**REMARKS**

Amendment Under 37 C.F.R. § 1.116  
U.S. Application No.: 10/058,804

Attorney Docket No.: Q68166

Fig. 1

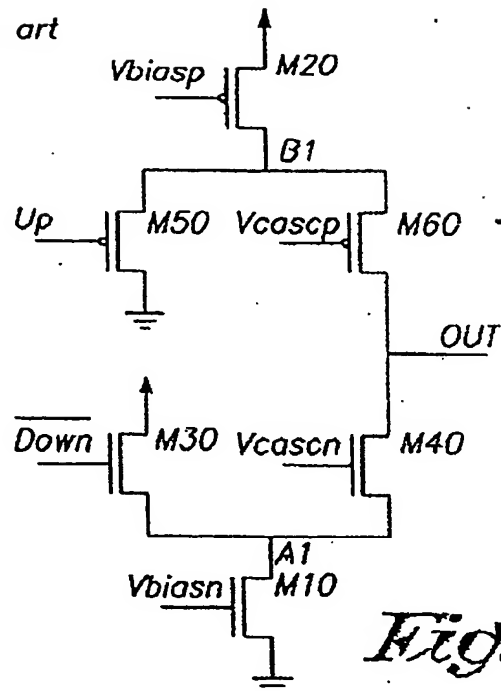
The Examiner objects to the drawings, asserting that Figure 1 should be labeled Prior Art. It is respectfully pointed out that Figure 1 filed on January 30, 2002, was labeled "Prior Art" as shown in the copy of the Drawings filed on January 30, 2002, which the Examiner will find attached. Accordingly, the Examiner is kindly requested to withdraw the objection and approve the formal drawings filed on January 30, 2002.
